DEPARTMENT OF THE ARMY  
TULSA DISTRICT, CORPS OF ENGINEERS  
POST OFFICE BOX 61  
TULSA, OKLAHOMA 74121-0061  
August 13, 1993

This is in response to your letter of June 30, 1993, requesting our review of the proposed plans for the new bridge crossing of the Big River on South Broadway, Wichita, Kansas.

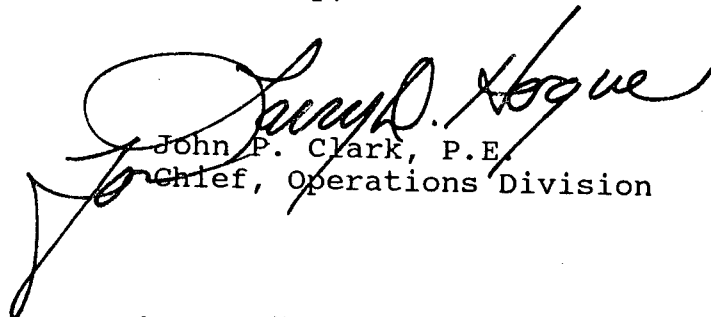
c. Comment 3 (Sheet 25). The piers on the proposed bridge do not align with the piers on the existing structure. Having the piers of both structures aligned is recommended.

d. Comment 4 (Sheet 25). The south abutment of the northbound lanes appears to extend into the flow area. This encroachment on the effective flow area should be considered.
